| <b>REQUEST FOR INFORMATION</b> | <b>DATE:</b> August 25, 2016 | <b>NO.:</b> RFI-255 |

Project Name: 15051-Webster University Interdisciplinary Science Building

Subject: Connection detail for grade beam to C.3 line transition

**S0101**

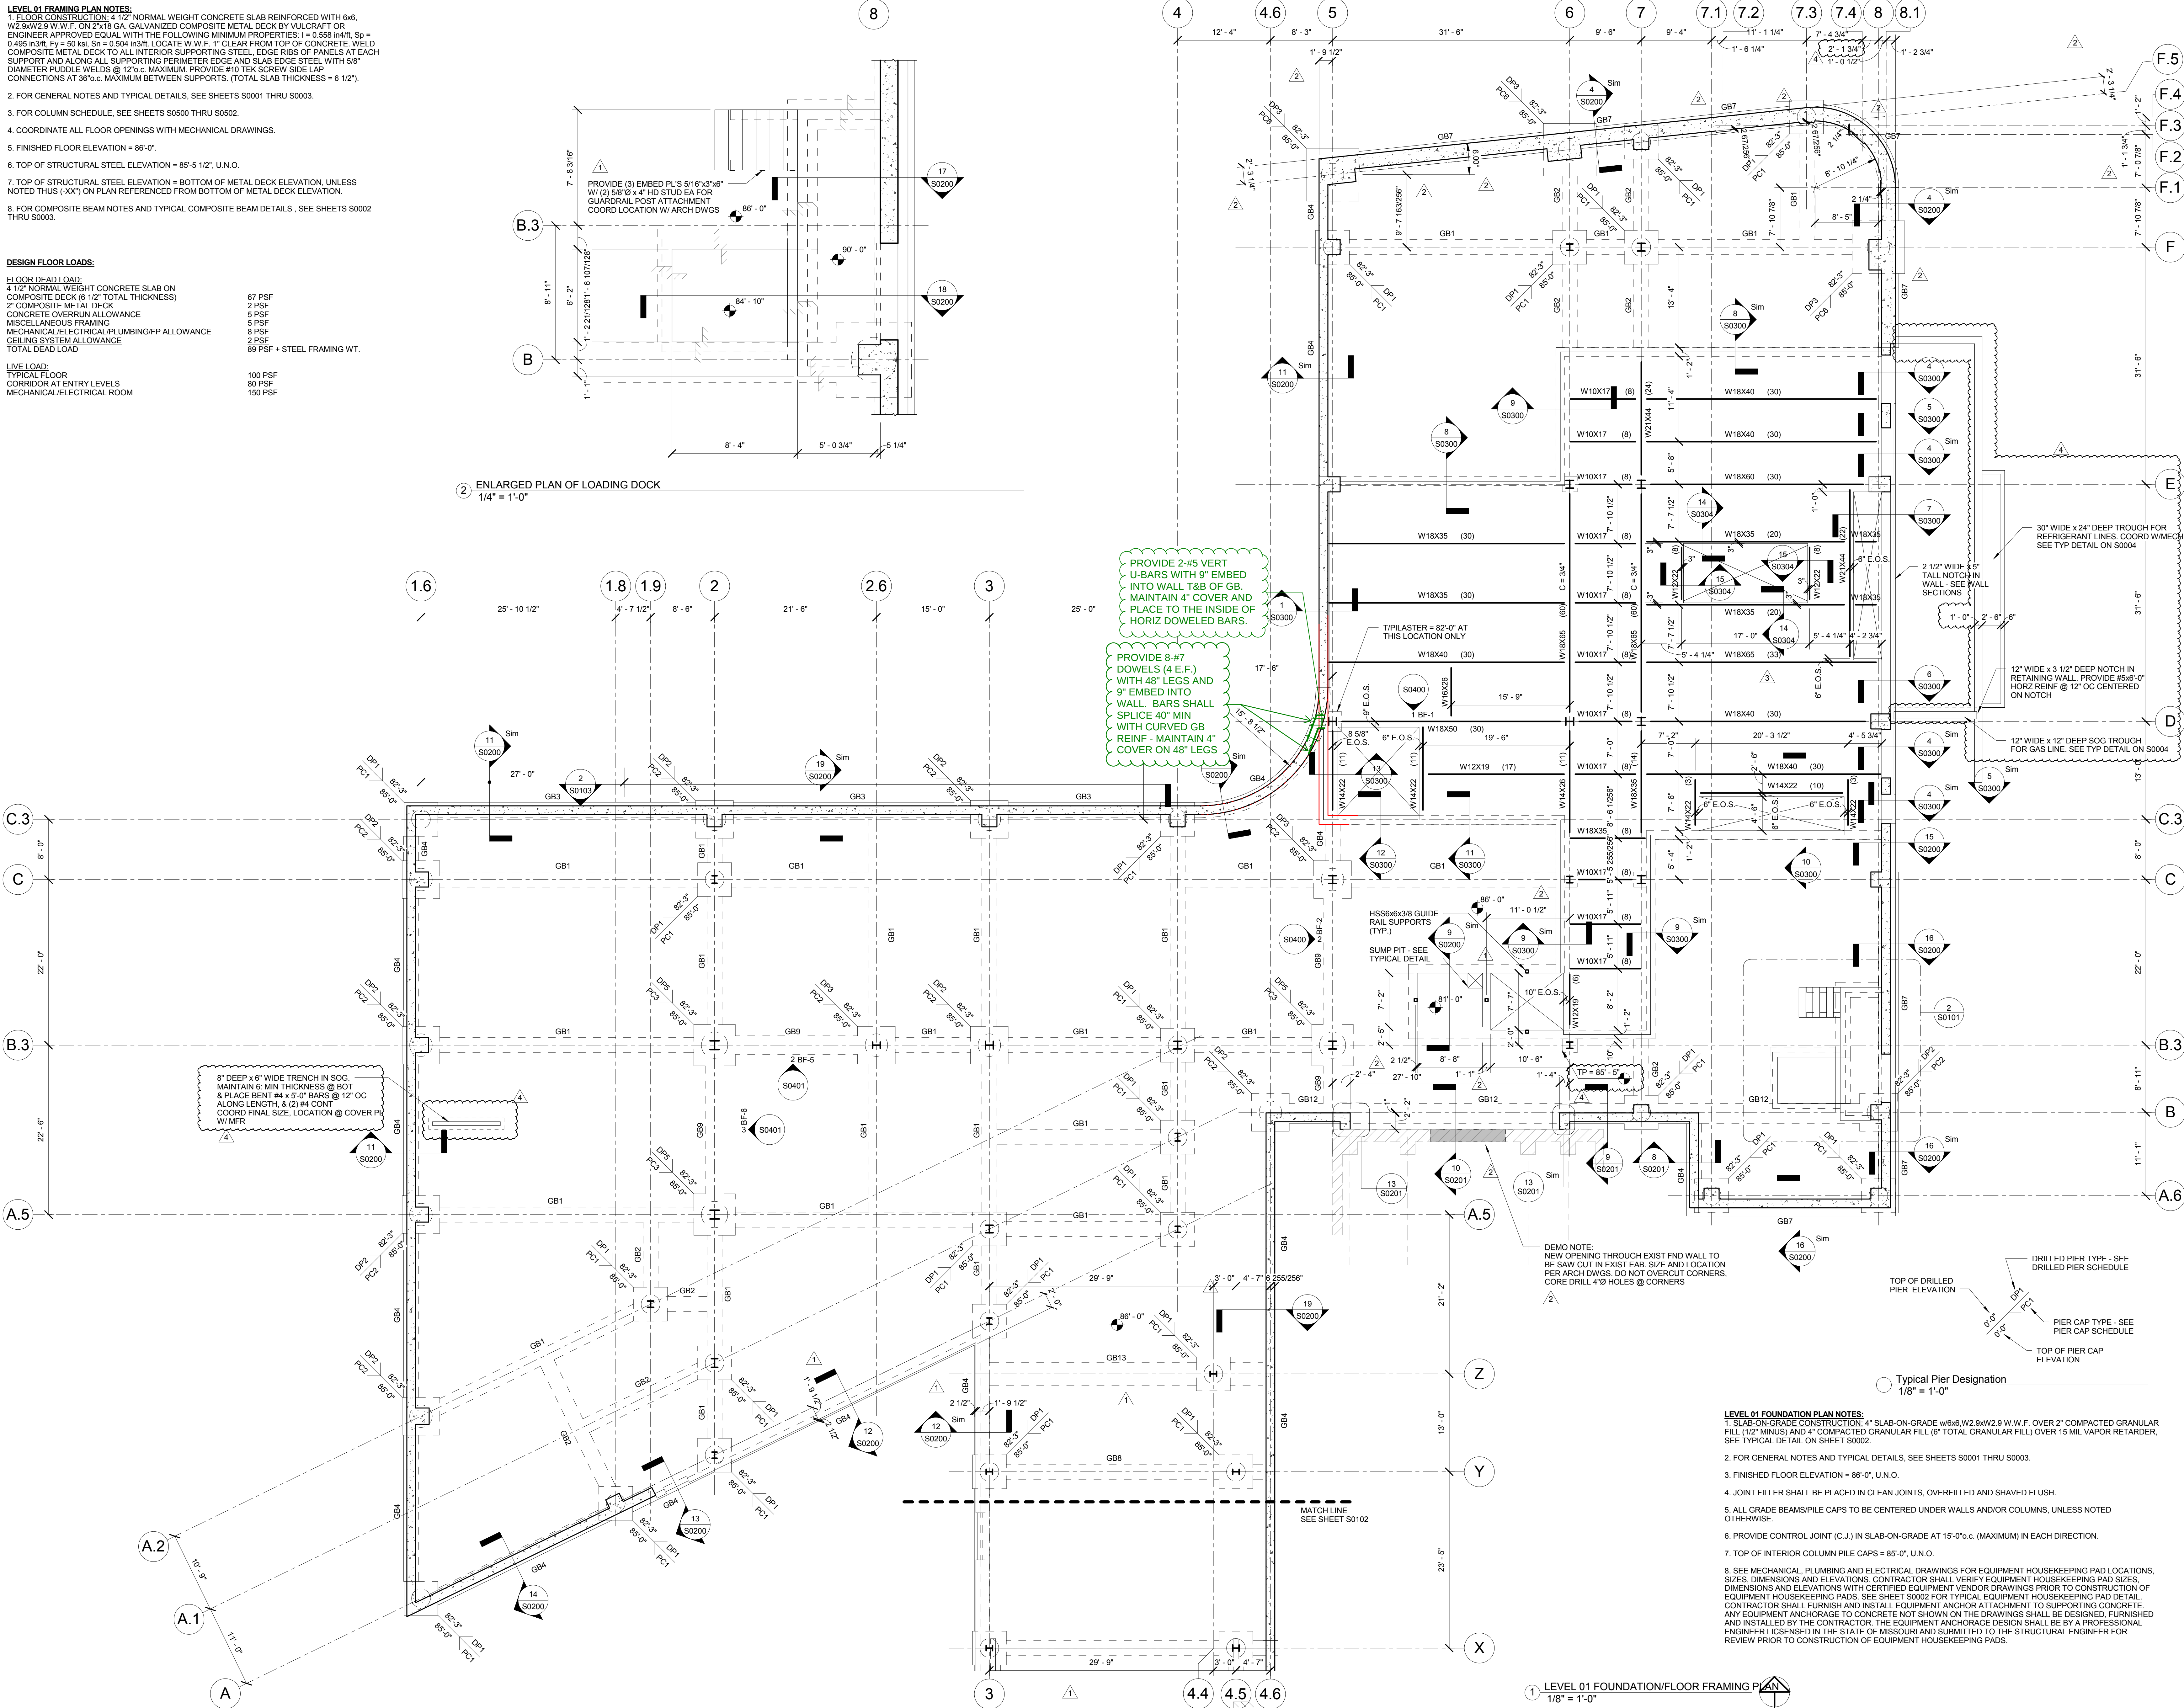
Please provide a connection detail where the grade beam from C.3 line transitions to column line 5 using the radius. Is it acceptable to drill and epoxy dowels for the grade beam into Level 0 foundation wall on column line 5 wall using the Hilti-HY 200A epoxy? If acceptable, please provide embedment requirement.

WALL & GRADE BEAM CONSTRUCTION JOINTS ARE LOCATED ON THE EAST SIDE OF THE PILASTER/PIER CAP AT C.3-3. PIER CAP AT C.3-4 IS NOT POURED AT THIS TIME. THE AREA BETWEEN GRIDS 3 & 5 IS BEING USED AS A ACCESS RAMP FOR THE SITE. GRADE BEAMS SHALL BE PLACED ON COMPACTED BEARING MATERIALS THAT MEET A BEARING CAPACITY OF 3KSF TO BE VERIFIED BY THE GEOTECHNICAL ENGINEER. THE BEARING MATERIAL ALONG GRID 5 WALL FOR A DISTANCE OF 8 FEET WEST FROM THE WALL SHALL NOT BE COMPACTED FOR BEARING. BACKFILL IN THIS AREA SHALL FOLLOW THE DRAIN PIPE INSTALLATION DETAIL IN THE PLUMBING DRAWINGS AND AS DEFINED IN THE GEOTECHNICAL REPORT. REINFORCING AT GRID 3 SHOULD HAVE ALL HORIZONTAL BARS FROM GRADE BEAM AND WALL EXTENDED FOR A CLASS "B" SPLICE (VERIFY). GRADE BEAM REINF AT THE INTERSECTING GRID 5 WALL SHALL HAVE REINF SET INTO THE WALL WITH HILTI HY-200 ADHESIVE SYSTEM PER ATTACHED SKETCH. CONCRETE POUR OF WALL SHALL BE MONOLITHIC FROM GRID 3 TO GRID E.
